Pakistan Renewable Energy Coalition
Together for a Renewables Powered Pakistan

A briefing paper

NEGLECTED POTENTIAL

How the Latest IGCEP Fails
Renewable Energy Future in
Sindh and Balochistan

IGCEP 2022-31
NTDC's Projection for New Capacity Additions

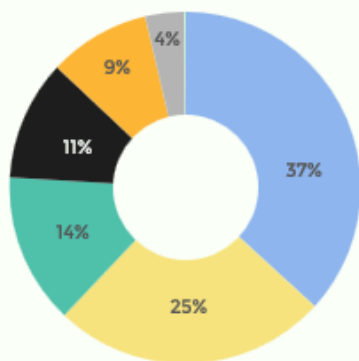
The exclusion of cost-effective Variable Renewable Energy (VRE) from the latest IGCEP contradicts the least-cost principle of the IGCEP model. The VRE share has been reduced to 13.3 per cent from the previously projected 29.6 per cent in IGCEP 2022-31. This reduction represents a substantial decrease in the planned contribution of wind, solar, and other VRE sources. Notably, the solar share, including net metering, is projected to drop to 10 per cent by 2034. This scenario contrasts sharply with the targets of the Alternate and Renewable Energy (ARE) Policy of 2019 of the government, which aimed for a VRE share of at least 30 per cent by 2030. The reduction in renewable energy targets directly impacts the provinces of Sindh and Balochistan, which possess immense potential for solar and wind energy.

IGCEP 2023-34
NTDC's Projection for New Capacity Additions

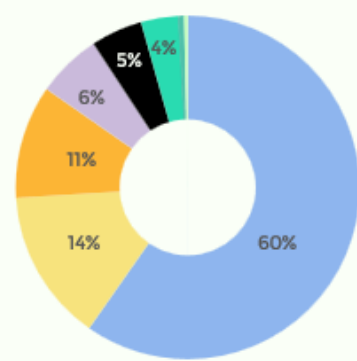
The latest IGCEP iteration also raises concerns with its overreliance on hydropower, where 70 per cent of the committed projects are hydro-based. By 2033-2034, the plan projects that 40 per cent of energy demand will be met by hydro, followed by 5 per cent solar, 3 per cent wind, and 2 per cent bagasse. The remaining 44 per cent will still rely on expensive conventional thermal sources. Hydropower and Thar Coal are favoured for generation expansion, cited for their potential to lower consumer costs and enhance energy security.
